OPEN
Compute Project

OCP NIC 3.0 Design Specification

Version 0.01

Author: OCP Server Workgroup, OCP NIC subgroup

Figure 5: Example Large Card Form Factor

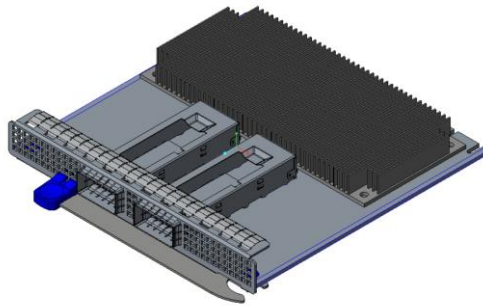
Commented [HS3]: For some use cases, secondary connector is not required to be used for large card size. We need to discuss and clarify it.

Figure 6: Primary Connector (4C + OCP Bay) with 4C and 2C Add-in Cards

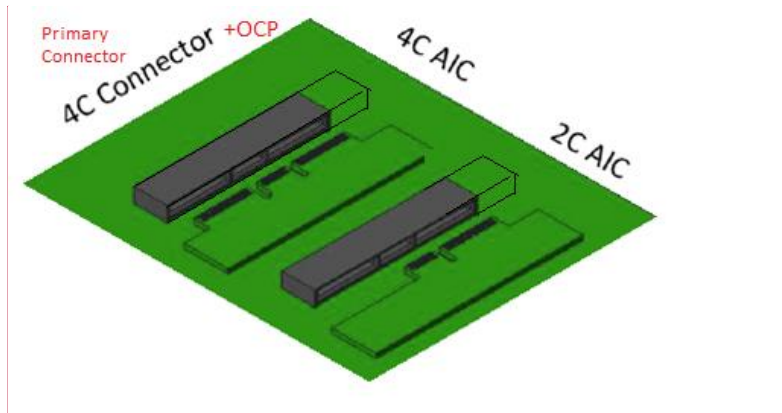
Commented [TN4]: This needs to be updated to show the OCP bay along with the secondary connector location..

Figure 2120: NC-SI Over RBT Connection Example – Single Primary Connector

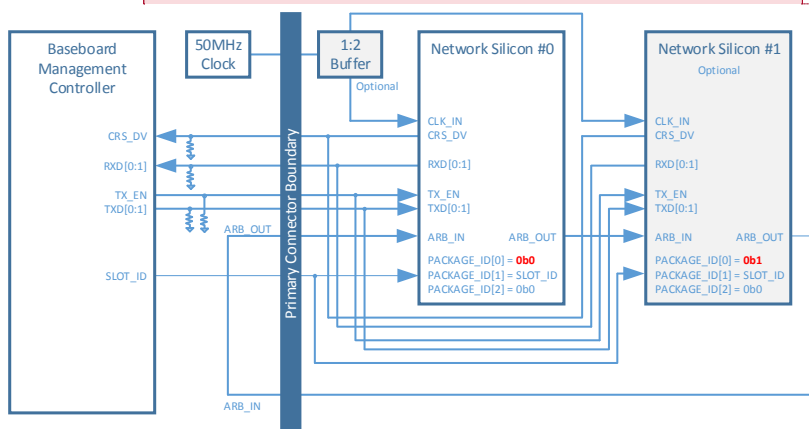
Commented [HS12]: We should delete this table and just reference DSP0222 Section 10 to avoid any inconsistencies.

Commented [TN13R12]: Do you mean Table 16, above?

[Figure 3433](#): Block Diagram for Emulated Thermal Reporting

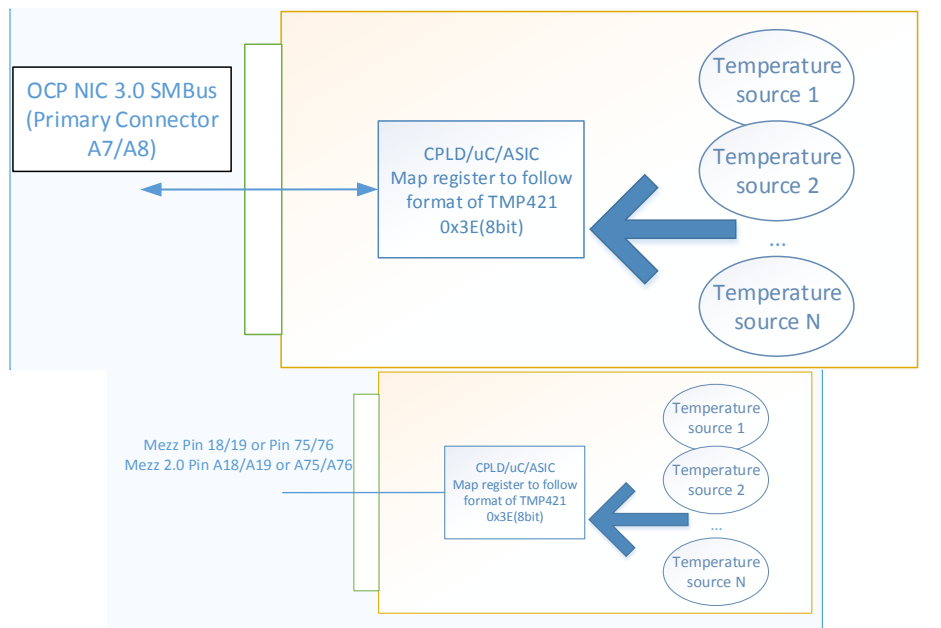
Commented [JN20]: Needs update

Figure 3534: Block Diagram for Remote on-die Sensing

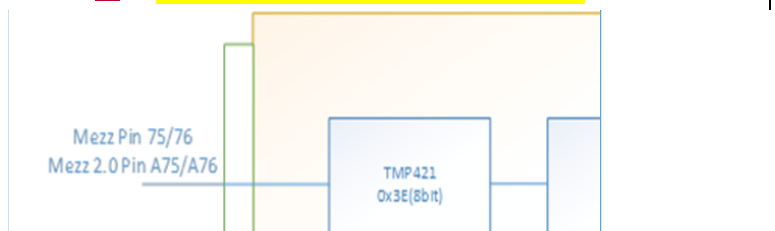
Commented [JN21]: Update pin # of diagram
